STATE OF NORTH CAROLINA
DEPARTMENT OF TRANSPORTATION

ADDENDUM 2
Division 3 Roadside Environmental Shelter Renovation
Burgaw, NC SCO ID# 07-07006-02A
June 9, 2010

BULLETIN #1 ID # 07-07006-02A

BURGAW ROADSIDE STORAGE
SHELTER RENOVATION
HIGHWAY DIVISION 3, NCDOT
PENDER COUNTY, NORTH CAROLINA

EXISTING SERVICE DOOR & ELECTRICAL PANEL

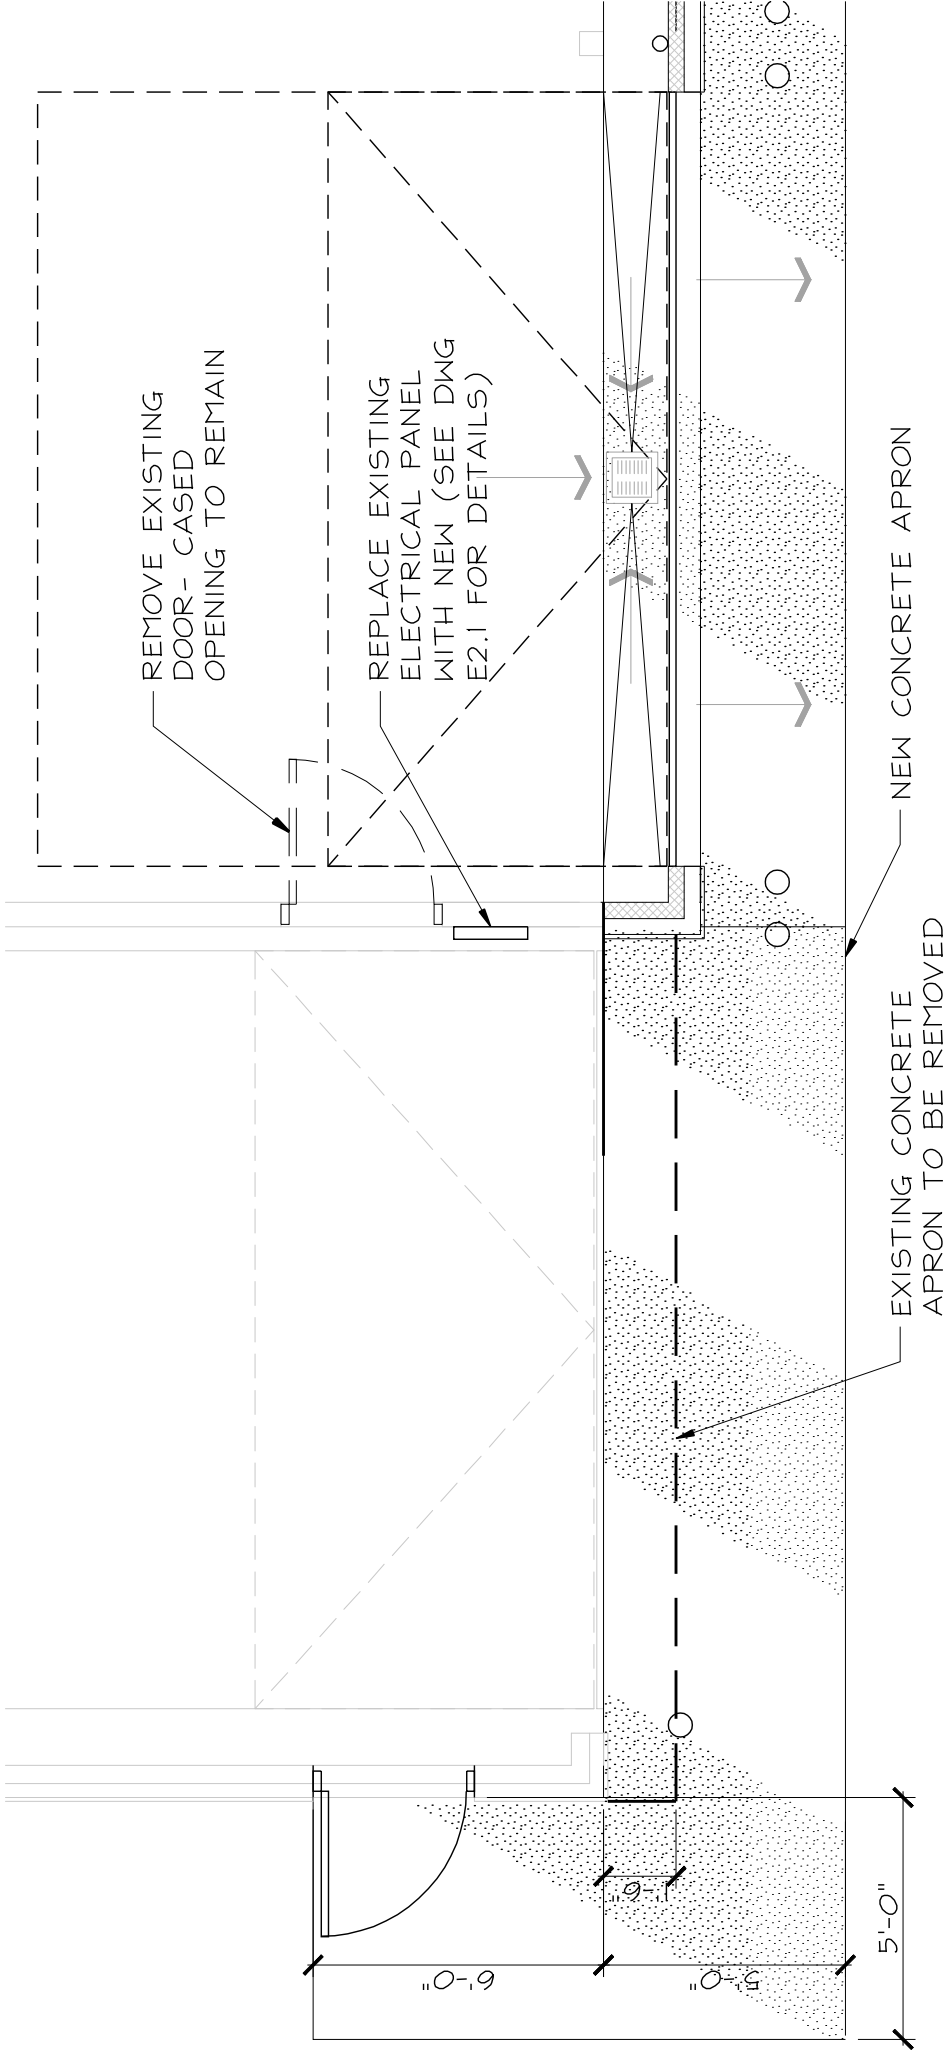
Item 10: See the attached Bulletin #1 drawing for the corrected location of the existing personnel door and electrical panel. The new panel will be placed in the same location as the existing panel.

EXISTING SERVICE DOOR AND EXISTING/ NEW ELECTRICAL PANEL LOCATION IS AS SHOWN IN THIS BULLETIN. GC TO REMOVE EXISTING APRON IN FRONT OF ENCLOSED BAY AND TO POUR A NEW APRON AS A CONTINUATION OF THE NEW APRON IN FRONT OF THE OTHER FOUR BAYS. THIS APRON CONTINUES AROUND THE EAST SIDE TO BECOME THE NEW 5' WIDE SIDEWALK AS SHOWN IN THIS BULLETIN.

PARTIAL HVAC PLAN

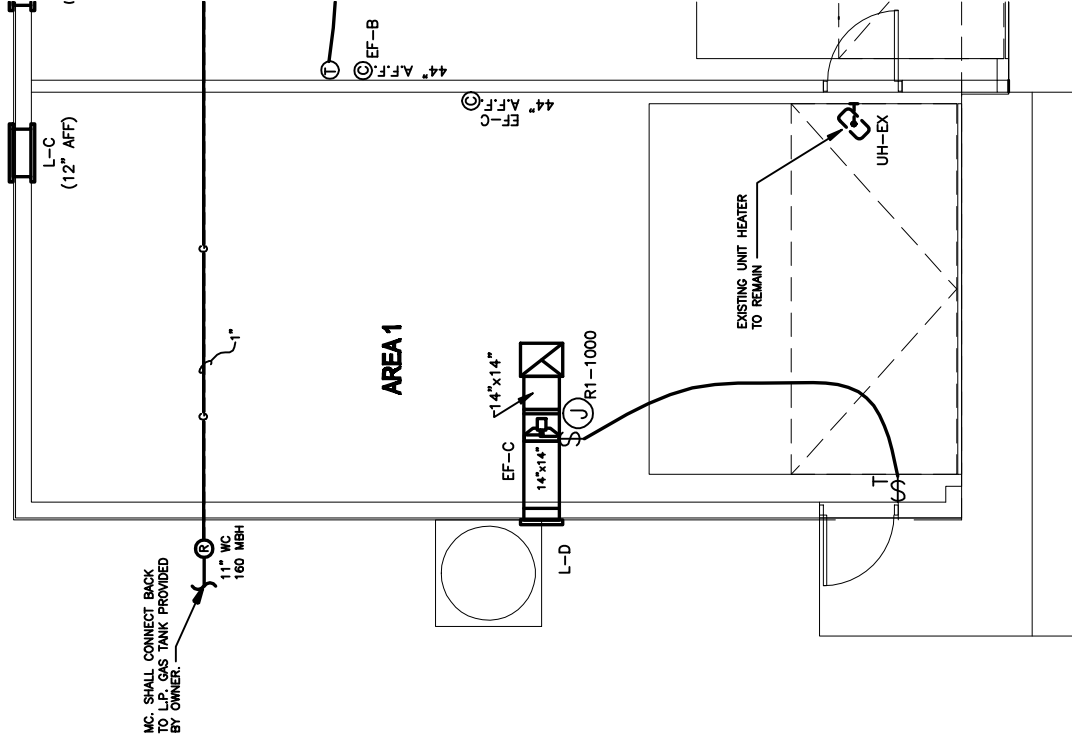
BULLETIN #2 ID # 07-07006-02A
REFERENCE DRAWING M1.1:

REMOVED ONE OF THE RADIANT HEATERS, TOTAL OF 3 REMAIN IN THE
CONTRACT DOCUMENTS. EXISTING ELECTRIC UNIT HEATER TO REMAIN
AS SHOWN IN THE PARTIAL PLAN ATTACHED.

PARTIAL HVAC PLAN

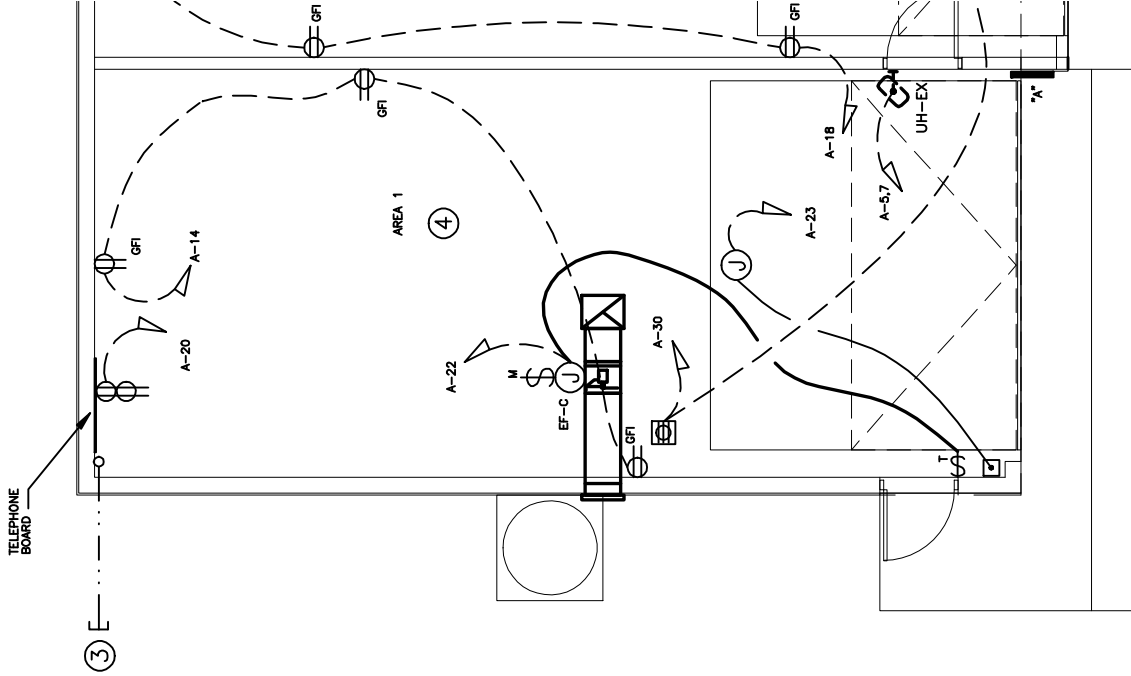
BULLETIN #3 ID # 07-07006-02A
REFERENCE DRAWING E1.1:

REMOVED ONE OF THE RADIANT HEATERS, TOTAL OF 3 REMAIN IN THE CONTRACT DOCUMENTS. EXISTING ELECTRIC UNIT HEATER TO REMAIN, RECONNECT TO NEW PANEL CIRCUIT INDICATED ON THE ATTACHED PARTIAL PLAN. REVISED PLAN NOTE #3 TO CLARIFY TELECOM CONDUIT LENGTH.

TELEPHONE BOARD DETAIL

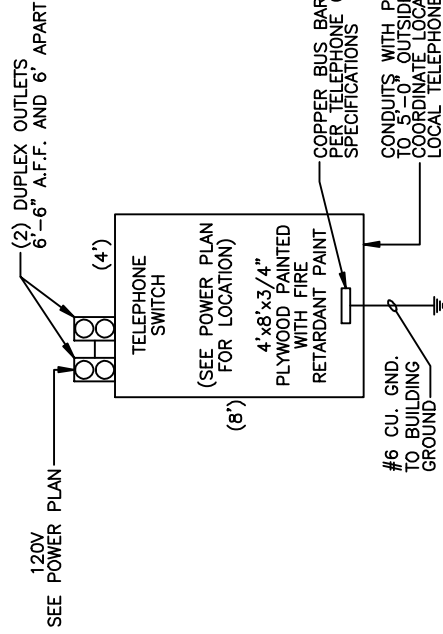
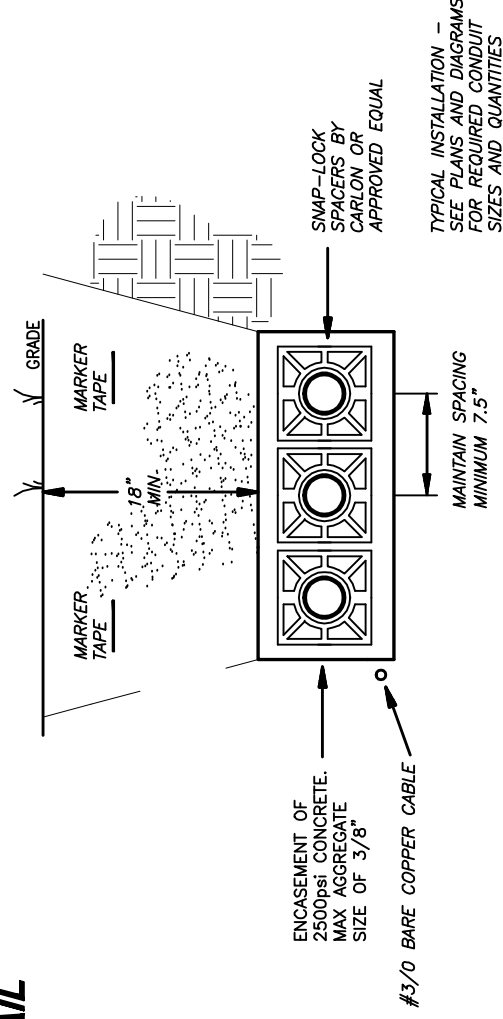
BULLETIN #4 ID # 07-07006-02A

REFERENCE DRAWING E1.2:

CHANGED DETAILS TO REFLECT PROPER LOCATION AND LENGTH OF TELECOM CONDUIT AND TO CLARIFY THAT DUCT BANK IS FOR POWER FEEDER ONLY.
